Access Compliance Report Public Rights-of-Way (Curb Ramps)

Main Street: N/A Cross Street: NARROW_CANYON_RD Location: E

ADA ID: RPRK211103161232 Ramp Type: Type 4 - Parallel Initial Pass/Fail: Pass Overall Compliance: No Severity Score: 25

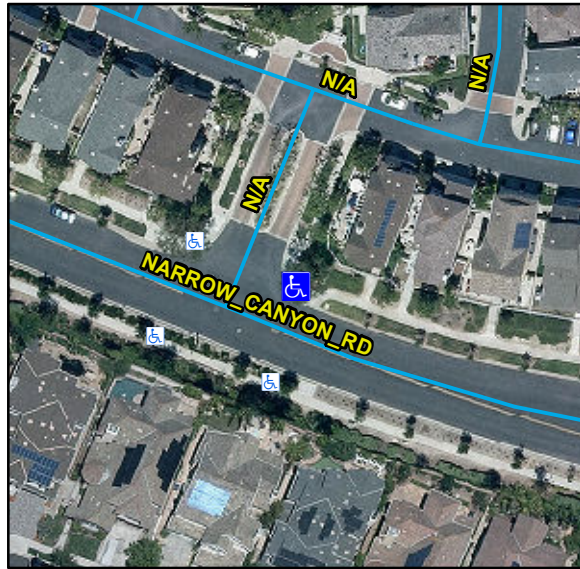
Compliance	Description	Data	Compliance	Description	Data
N/A	Ramp Length LT (in)	136	N/A	Ramp Length RT (in)	134
Yes	Ramp Width LT (in)	88	Yes	Ramp Width RT (in)	88
Yes	Ramp Run Slope LT (%)	7.7	Yes	Ramp Run Slope RT (%)	6
Yes	Ramp Cross Slope LT (%)	0.2	Yes	Ramp Cross Slope RT (%)	1.1
N/A	Landing Present	No	No	DWS Provided	No
N/A	Landing Length (in)	N/A	N/A	DWS Contrast	N/A
No	Landing Width (in)	N/A	N/A	DWS Length (in)	N/A
No	Landing Run Slope (%)	N/A	N/A	DWS Full Width	N/A
No	Landing Cross Slope (%)	N/A		DWS Offset Type	N/A
N/A	Landing Movement Obstructed?	No	N/A	DWS Offset Left (in)	N/A
	Landing Movement Type	Curb	N/A	DWS Offset Right (in)	N/A
N/A	Landing Shared	N/A			
N/A	Clear Space	Yes			
N/A	Clear Space To Crosswalk (in)	48			
N/A	Marked Crosswalk 1	No	N/A	Marked Crosswalk 2	No
	Crossing 1 Direction	NW		Crossing 2 Direction	SW
N/A	Marked Crosswalk 1 Width (in)	N/A		Marked Crosswalk 2 Width (in)	N/A
N/A	Ramp Inside Crosswalk 1	N/A	N/A	Ramp Inside Crosswalk 2	N/A

Crossing 1 Slope (%)	2.2		Crossing 2 Slope (%)	3.1
	Crossing 1 Cross Slope (%)	0.7		Crossing 2 Cross Slope (%)	2
Yes	Gutter Ponding	No	Yes	Curb Slope	6
No	Gutter Lip Height (in)	0.25		Road Run Slope (%)	1.4
No	Gutter Run Slope (%)	8.1		Road Cross Slope (%)	2.9
No	Gutter Cross Slope (%)	3.1	No	Perpendicular Joint Present	No
Yes	Overall Surface Condition	Acceptable			
	Cross Gutter Present?	No		Spandrel Present?	No
	Replace Cross Gutter?	N/A		Replace Spandrel?	N/A

Remove & Replace Curb Ramp With Two New Directional Ramps or Equivalent. Remove & Replace Gutter.
